BURLINGTON DEVELOPMENT REVIEW BOARD Tuesday December 19th, 2017, 5:00 PM Contois Auditorium, City Hall, 149 Church St, Burlington, VT AGENDA

TO: Development Review Board
FROM: Scott Gustin
DATE: December 19, 2017
RE: 18-0503CA; 92 Appletree Point Rd

Request: Request for amendment of zoning permit 17-0623CA/MA; Revisions to Building C and immediate site vicinity. Overall reduction of 50 parking spaces. No change in overall dwelling unit count (739).

SHADE CALCULATIONS: Plant Sizes and Shadow Offset

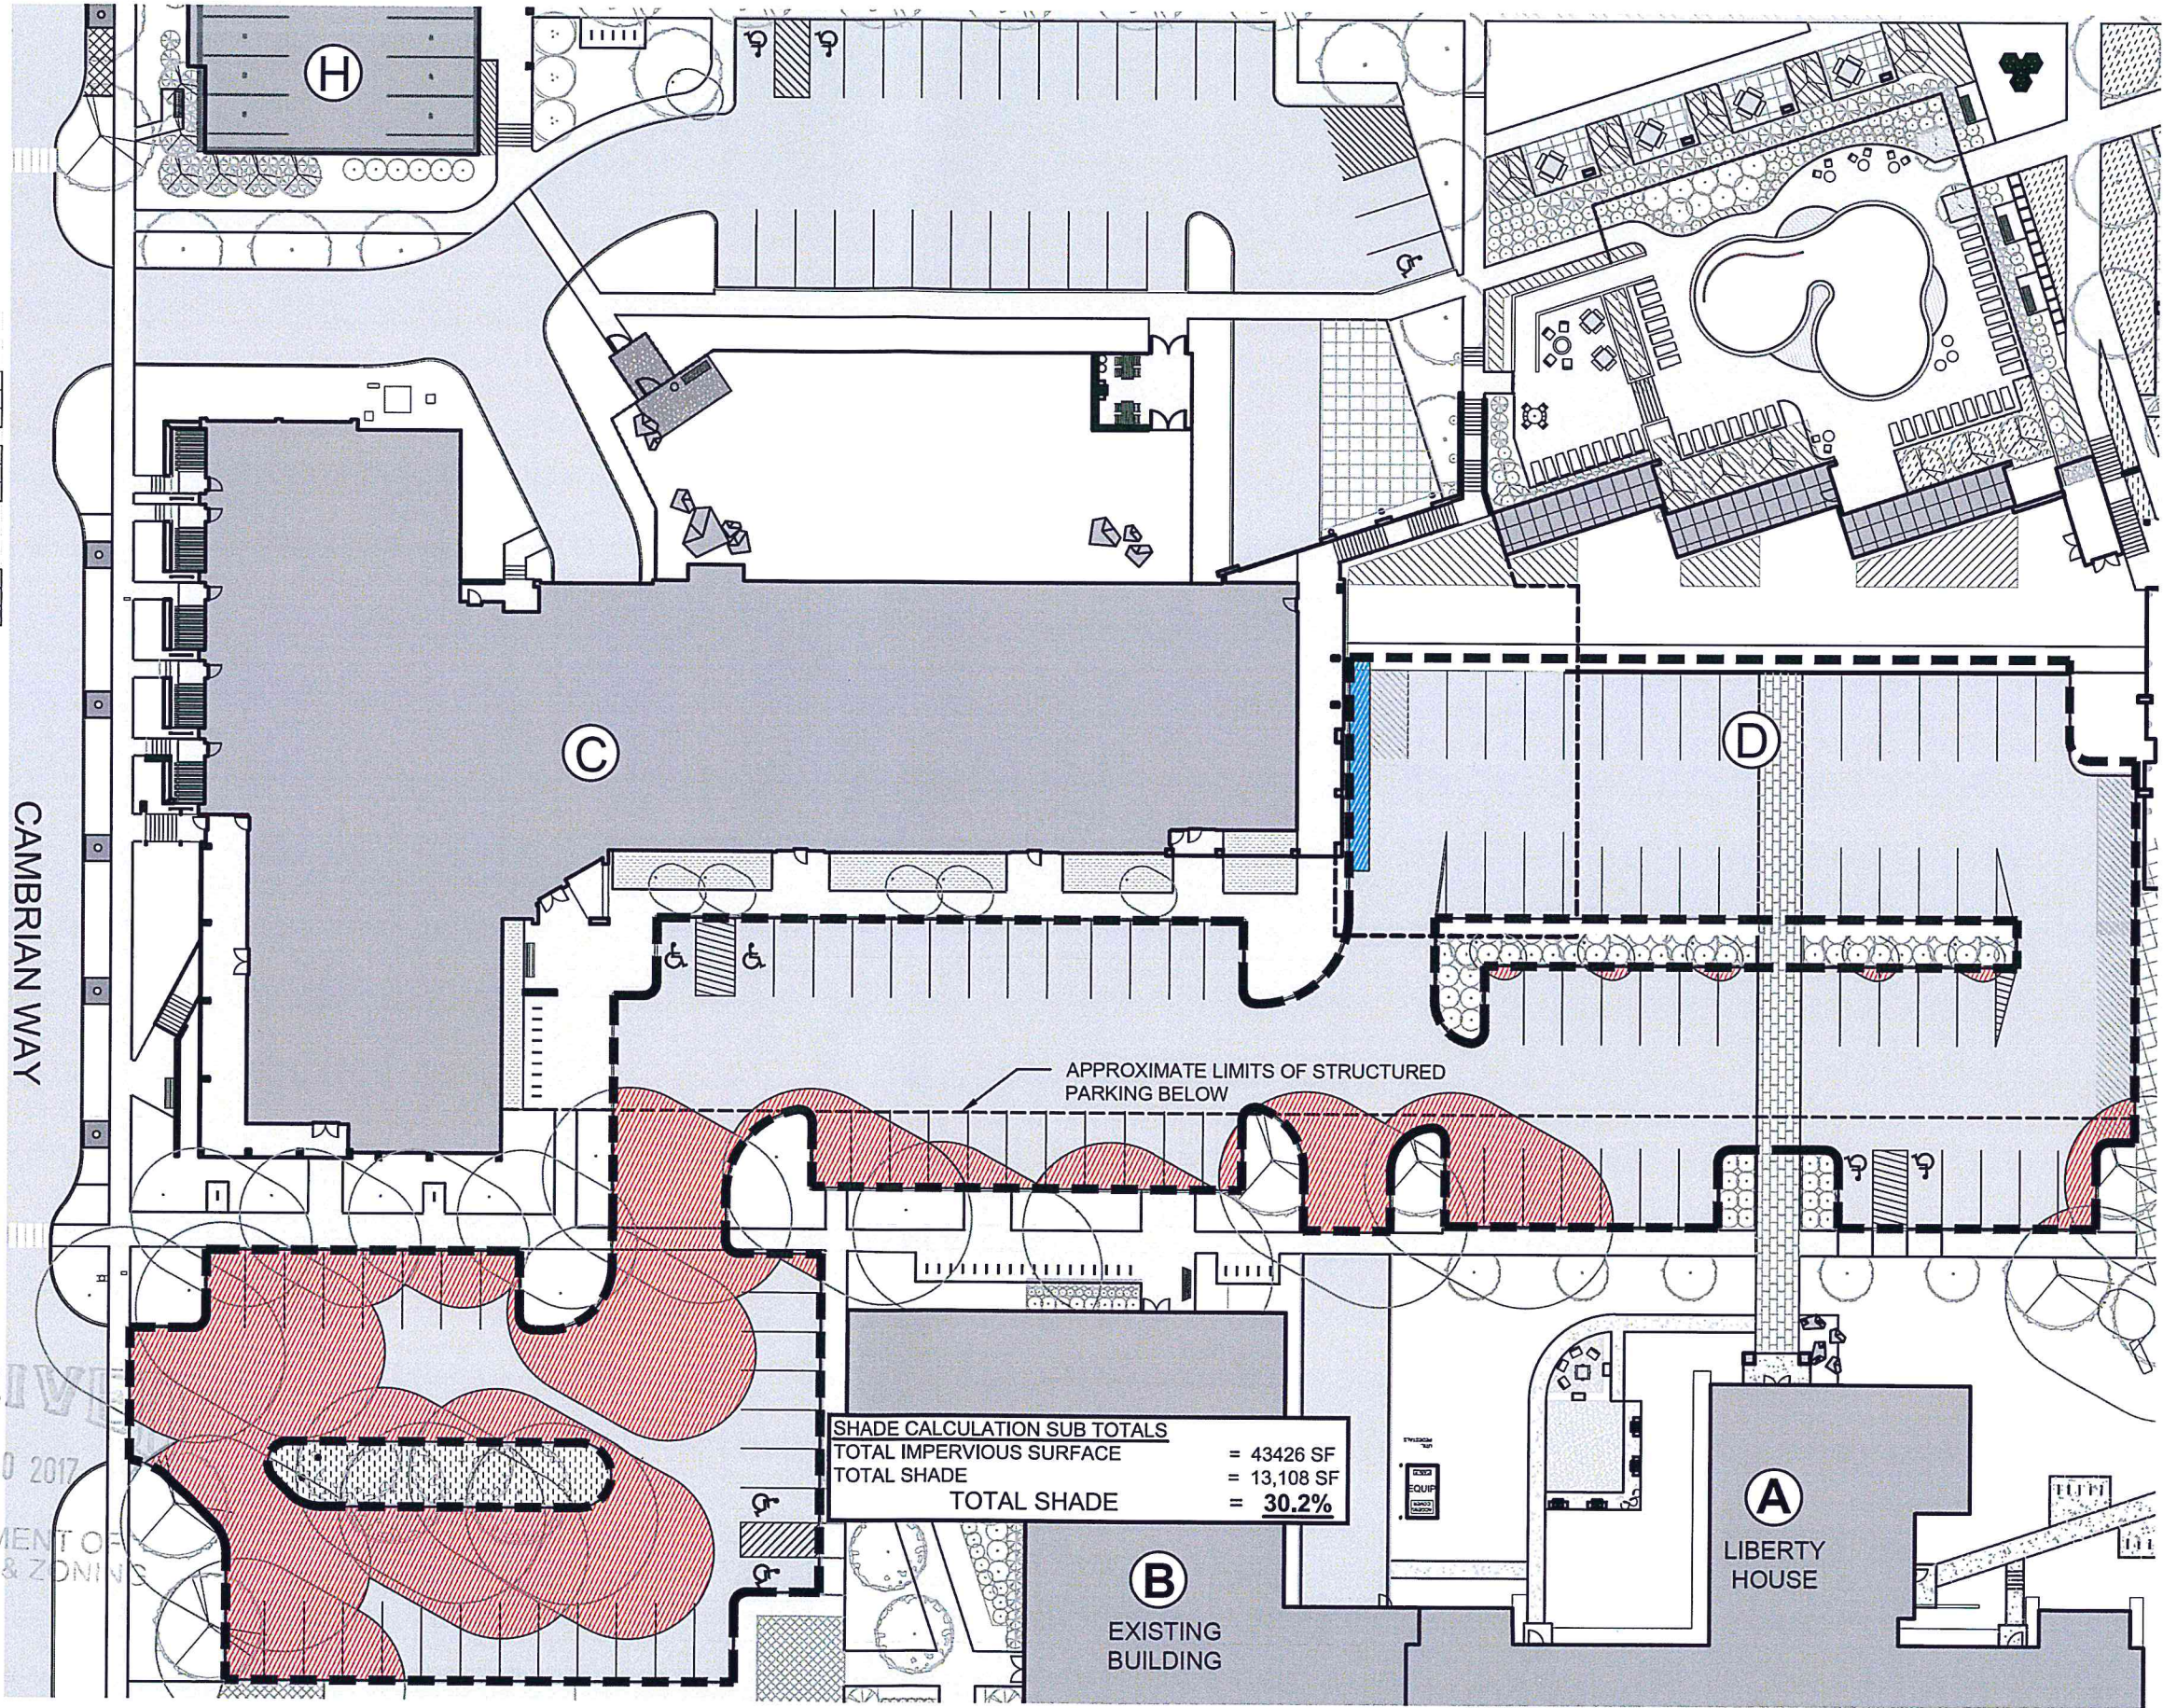
The requirement for 1 shade tree for every 5 parking spaces is met across the development. The shading plan submitted with this amendment demonstrates continued compliance with the 30% requirement. **(Affirmative finding)**

CD-1

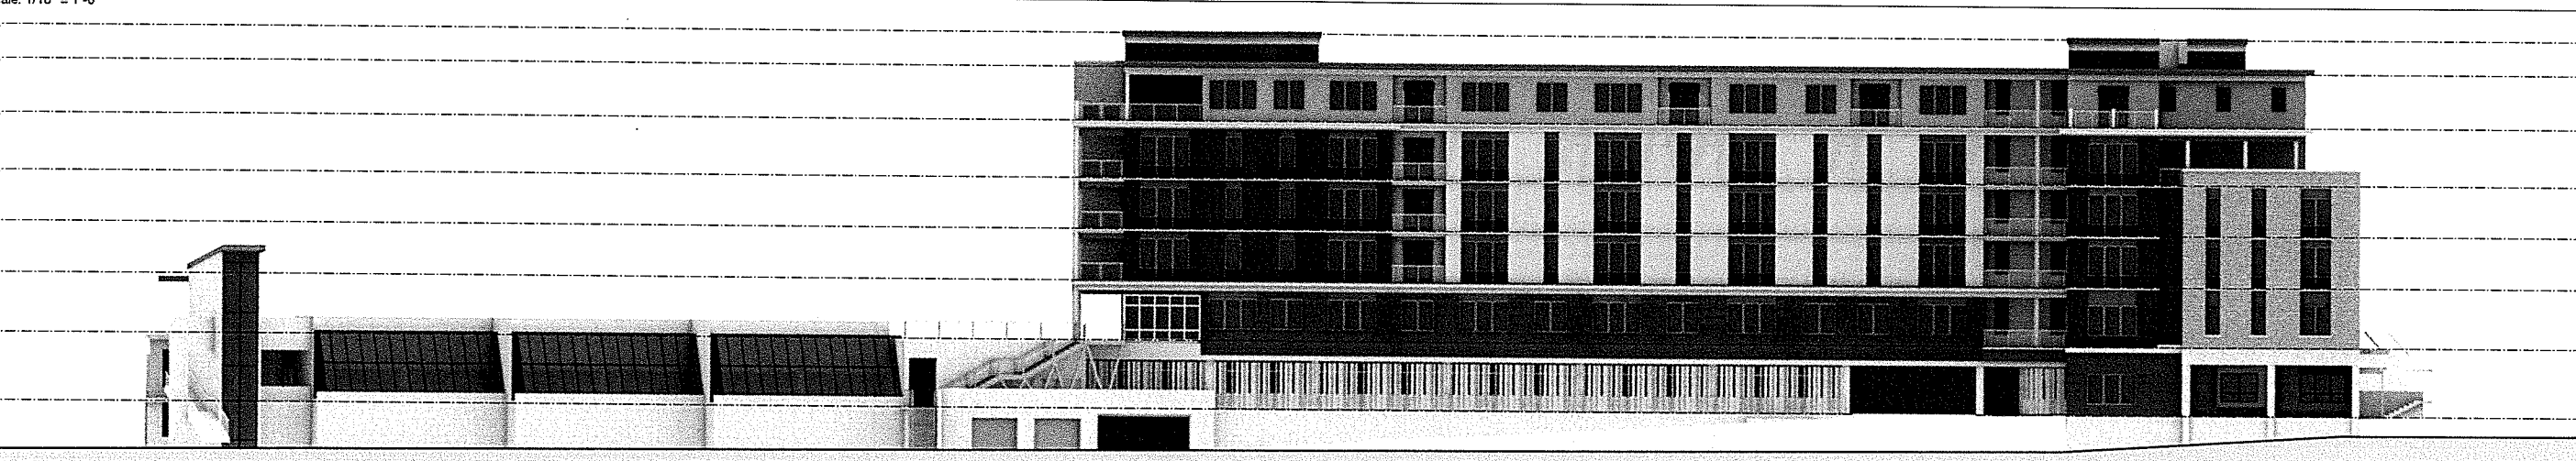
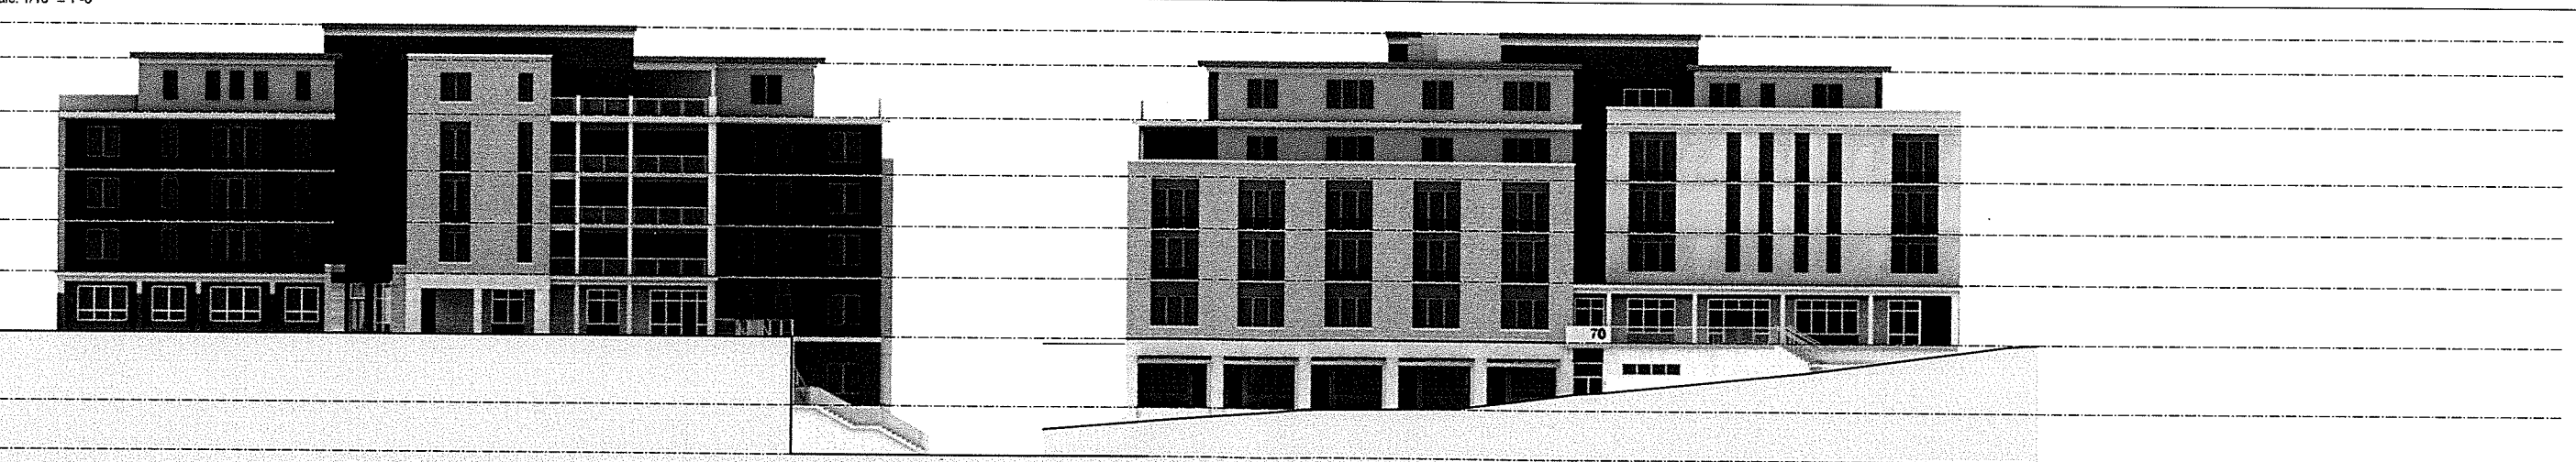
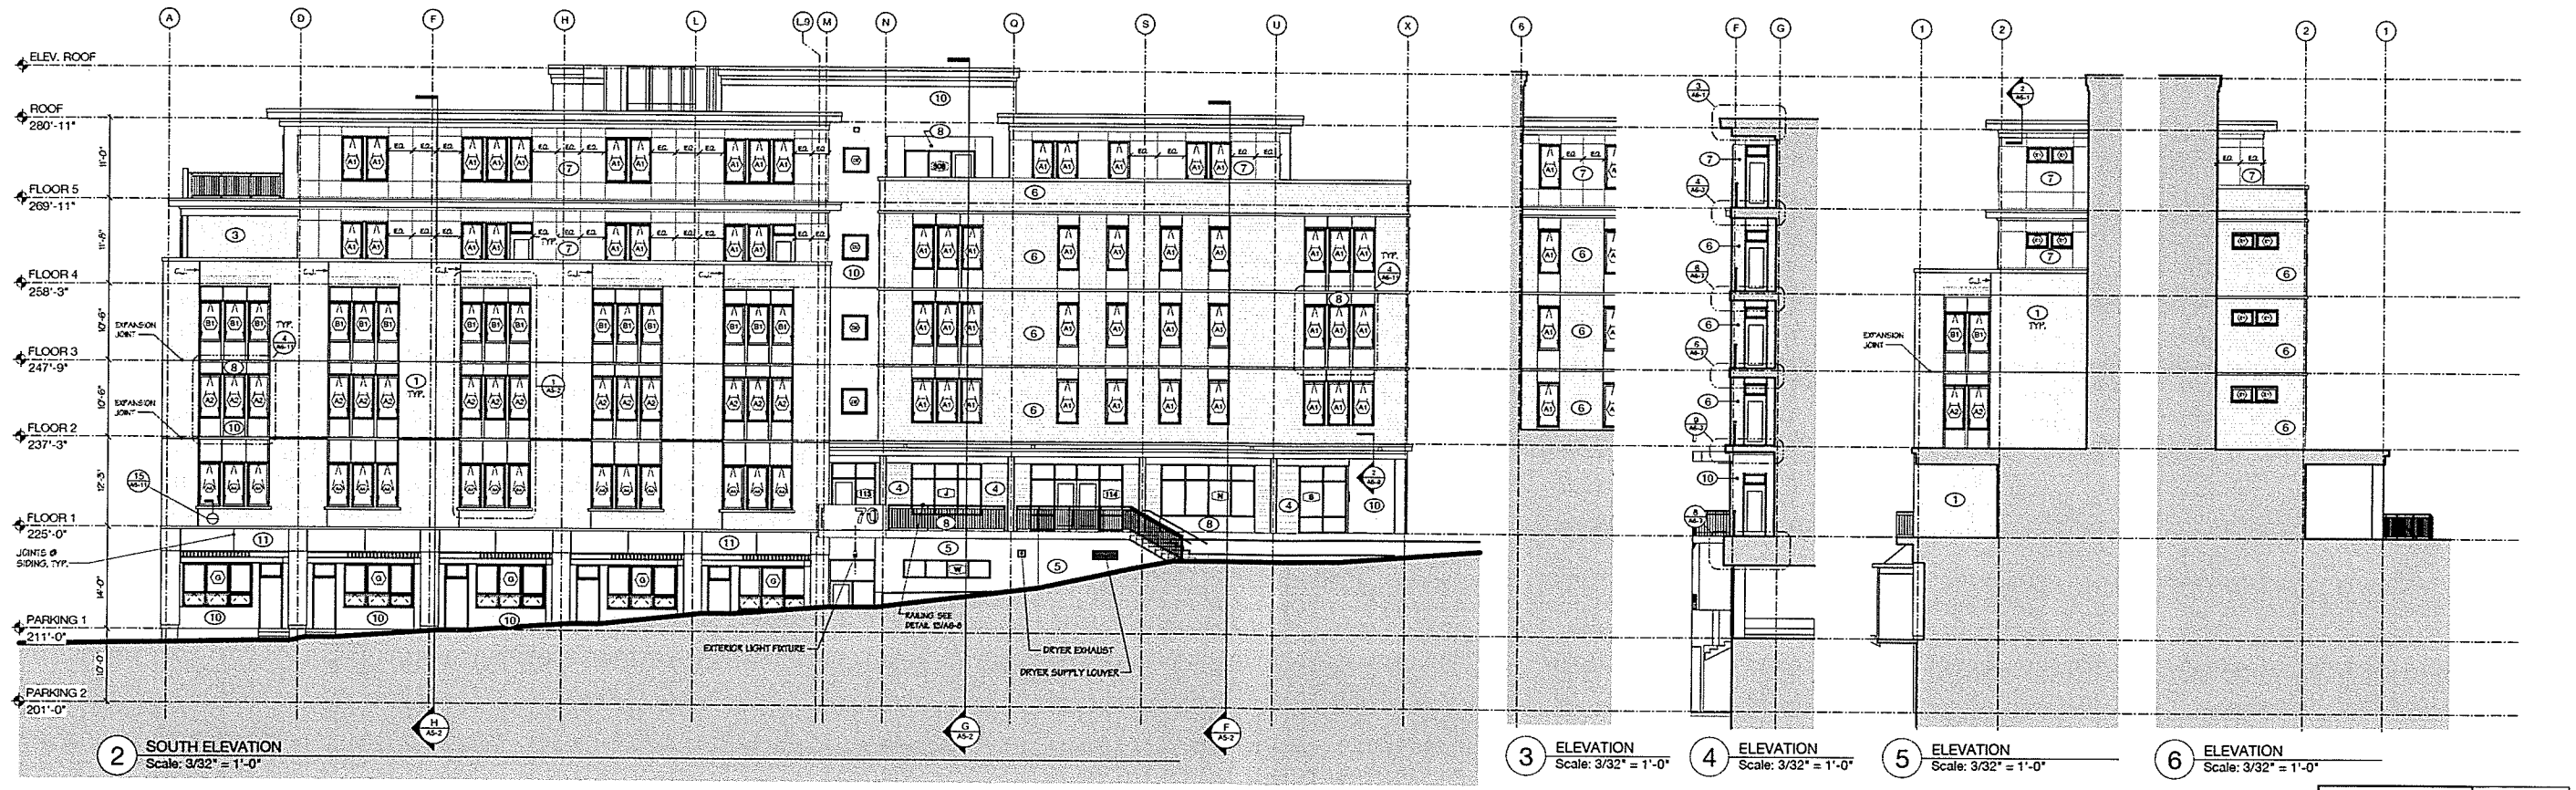
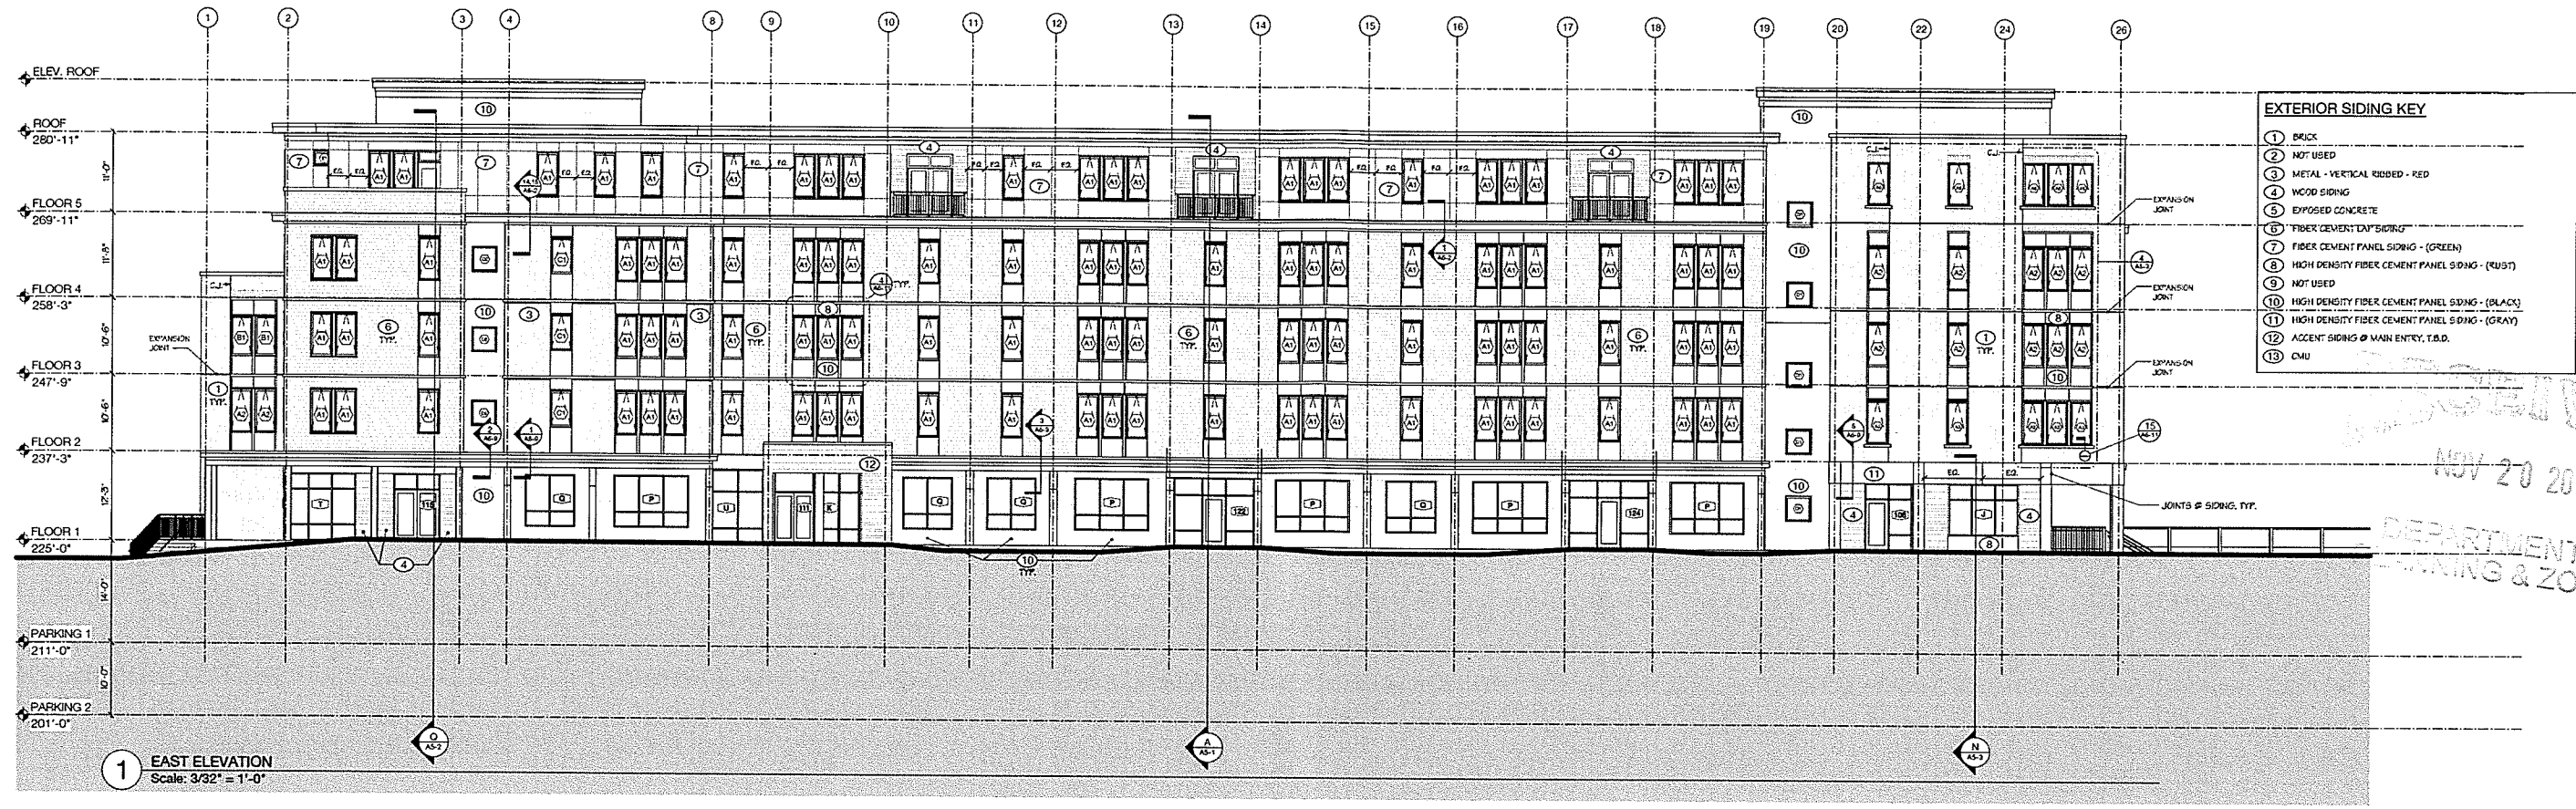
Removal of the at-grade under-building parking affects building fenestration. Where slatted screening once lined the parking area has now become enclosed building space with a new series of windows and doorways. Fenestration generally has been revised with new window styles, but the overall pattern remains largely unchanged. **(Affirmative finding)**

Building C faces south toward Cambrian Way. Little about its street presence will change. Some minor fenestration changes and an alteration to an exterior stairway are about the extent of proposed changes. **(Affirmative finding)**
